Appl. No. 10/524,991
Examiner: MAI, HAO D, Art Unit 3732
In response to the Office Action dated July 1, 2008

Date: December 1, 2008
Attorney Docket No. 10114961

AMENDMENTS TO THE DRAWINGS

REMARKS

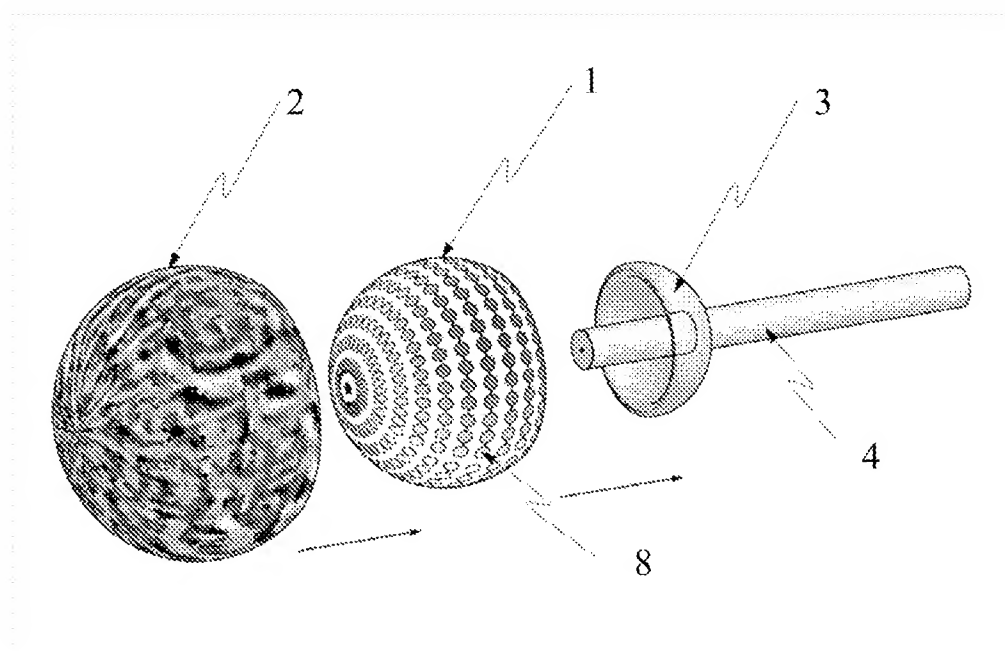
Thus, claim 1 recites an arrangement of a core having an exterior wall and hollow interior region and a sponge covering the exterior wall of the core. The sponge is fixed to the core with a latch plate. Claim 4 further recites that the exterior wall of the core is "reticular or porous." An embodiment of this arrangement in an exploded view is found in Fig. 7:

It is noted that sponge 2 is received on core 1 to cover the exterior wall of core 1 and fixed thereto by latch plate 3. Also see, for example, Fig. 1. By this arrangement, the sponge may take various 3-D shapes (for example, cup, cone, cylinder). As noted on page 2 of the application, "the contact side of the sponge which lines the core may be deformed to the core

Fig. 1 of Wiseman is reproduced below:

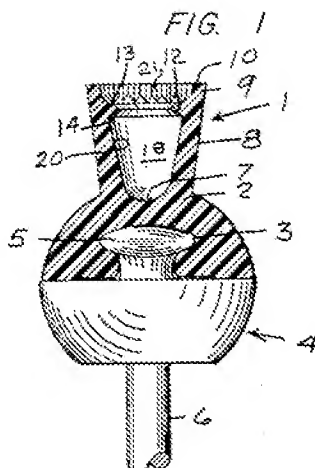
In Wiseman, a tooth polish cup formed by soft rubber and may be provided with a base 2 that is formed with a socket 3 for securing the cup onto a shank piece 4. The shank piece has a bulbous end 5 adapted to be held in socket 3. A reservoir 18 is provided for the tooth polishing material. See, column 2, lines 10-15 and column 3, lines 9-11 of Wiseman.

Claim 1 recites a cup-shaped core comprising an exterior wall and a hollow interior region, and a hydrophilic grindstone sponge covering the exterior wall of the core. Applicant notes that bulbous end 5 of Wiseman does not cover the exterior wall of the reservoir 18 (i.e., the alleged “core” of the claims), as recited in claim 1. To the contrary, bulbous end 5 extends from shank piece 4 and is inserted into socket 3 of base 2 to secure shank piece 4 to base 2.

Thus, even if Wiseman were modified in the manner set forth in the Office action (i.e., replacing element 5 of Wiseman with Van Leuwen’s hydrophilic polyurethane sponge), it would not meet the requirement that the hydrophilic grindstone sponge covering the exterior wall of the core, as recited in claim 1.

Applicant further submits that there would be no motivation to replace bulbous end 5 of Wiseman with a hydrophilic polyurethane sponge. The purpose of bulbous end 5 in Wiseman is to establish a mechanical connection between shank piece 4 and base 2 by fitting bulbous end 5 into a complementarily shaped socket 3. Col. 2, lines 10-21. There would be no reason to use a hydrophilic polyurethane sponge to establish and maintain this connection. To the contrary, Applicant submits that hydrophilic sponges would make an unsuitable material for fitting into a socket and maintaining a mechanical connection, particularly in an environment
